# 1965 Corvette: Service News: Vent the Window Regulator Motor

**Source:** Chevrolet Service News

**Date:** December, 1965 - Volume 37 - Number 11

**Fig. 1—Installing Window Regulator Motor Lower Attaching Screw (Vented)**

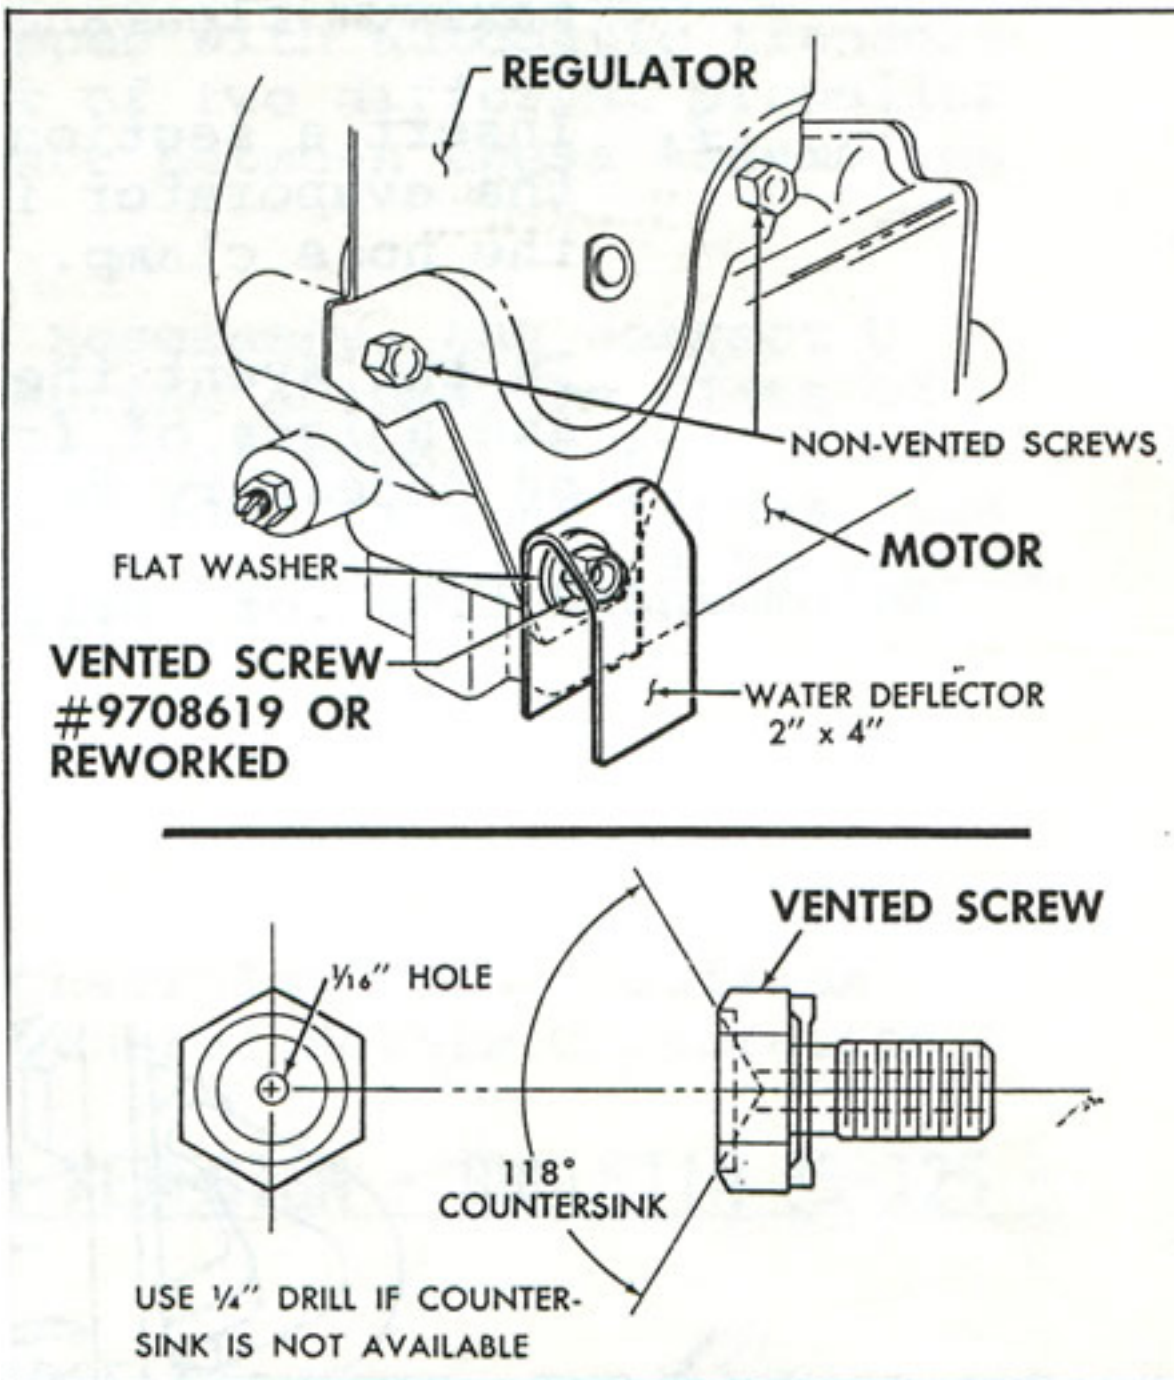
Refer to article "Replacing Window Regulator Motor", on the last page of November issue of Service News for door window regulator motor replacement . . . . and before completely replacing the motor, the lower attaching screw should be drilled through (hollow) to vent the motor (See Fig. 1). Venting the motor on all replacement motors will improve the reliability of power window motors.

**IMPORTANT:** *The screw to be vented is the lower one of the three screws. The motor housing is cored to permit air to enter motor interior only at this one location.*

**NOTE:** *If vented screw Part No. 9708619 is not available, drill a 1/16" hole through the center of one of the motor to regulator attaching screws and countersink the head of the screw (Refer to Fig. 1). Drill hole starting at threaded end of screw.*

Construct a water deflector, 2" x 4" with a 1/4" hole 1-1/4" from one end, from suitable water repellent material.

A hollow screw #9708619 will become available for service at a later date.

Production now incorporates this change.
